RUSSIAN MARITIME REGISTER OF SHIPPING

CIRCULAR LETTER

No. 314-21-1236c

amendments to the Rules for the Equipment of Sea-Going Ships, 2019, ND No. 2-020101-117-E

Fig.4.2.2
Example of the non-visible sector (Area A)

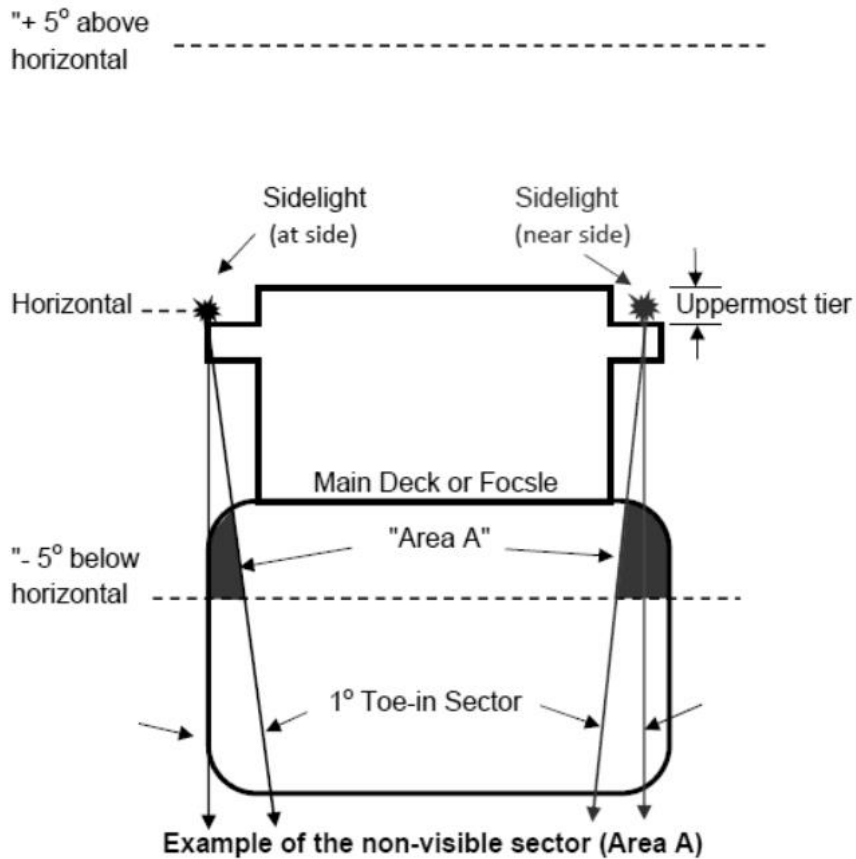
Para 4.2.2.2 is replaced by the following text:

"**4.2.2.2** The sidelights shall be protected by inboard shields with two transverse screens (fore and aft) perpendicular to the shield.

The breadth of the fore and aft transverse screens shall be such that the light would practically fade within 1° to 3° beyond the sectors stipulated under items 2 and 3 of Table 3.1.2. The full intensity of the side lights to be maintained in the forward direction of 1° outside the prescribed sector (one-degree toe-in sector) with the practical cut-off between 1° and 3°. This is needed to enable other ships to determine a "head-on-situation" as per COLREG rule 14.

Where sidelights, installed in a position at or "near the side" [1], are not fully visible at all angles from 5 degrees above to 5 degrees below the horizontal including the 1° toe-in sector (e.g., refer to Area A), then that installation is acceptable provided the installed sidelights are visible, with the ship in all normal conditions of trim corresponding to the lightest seagoing draft in the approved T&S Booklet, at a minimum distance of 1000 m measured from the stem when viewed from sea level throughout the horizontal plane of 112.5° defined by items 2 and 3 of Table 3.1.2 including the horizontal 1° toe-in sector in the forward direction.
